Quartz Valley Indian Reservation
13601 Quartz Valley Road
Fort Jones, CA 96032
530-468-5907

To: State Water Resources Control Board
From: Crystal Robinson
Environmental Director, Quartz Valley Indian Reservation
Date: July 23, 2018
Re: *Updated* Review and comments on Draft Water Quality Certification for Klamath River
Renewal Corporation's Lower Klamath Project

Sediment Load Quantification:

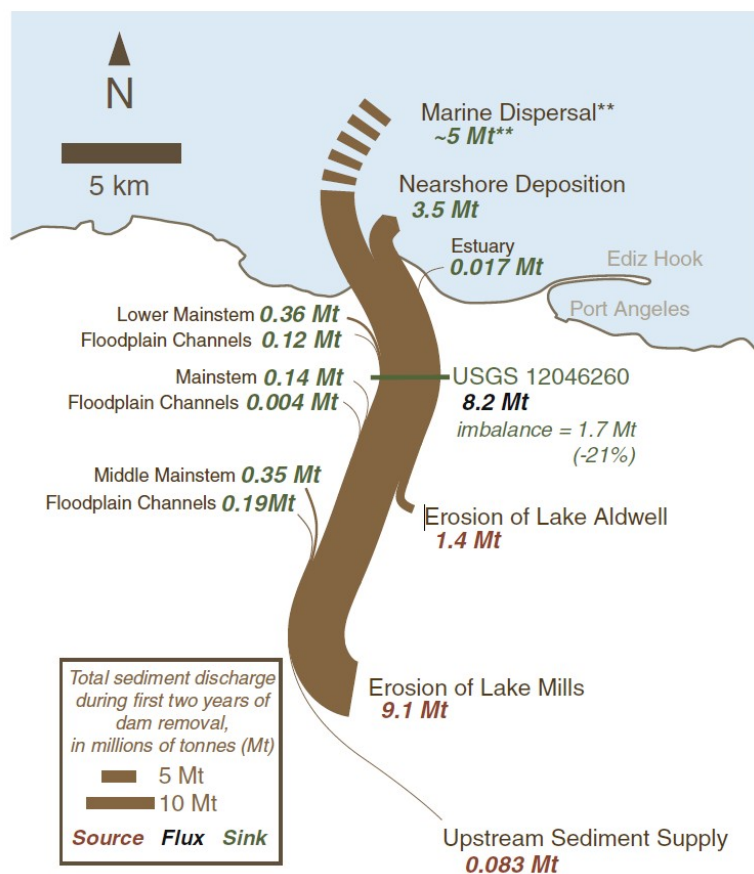
Page 17. We suggest expanding and clarifying this section. In addition to what is already stated in this section (i.e., quantifying erosion and deposition), we suggest that the continuous turbidity data and suspended sediment samples be combined with continuous flow data to estimate continuous sediment loads (i.e., continuous transport). These sediment loads and estimates of erosion and deposition should then be used to construct reach-scale and basin-scale sediment budgets, similar to what was done for the Elwah River dam removal (Warrick et al. 2015):
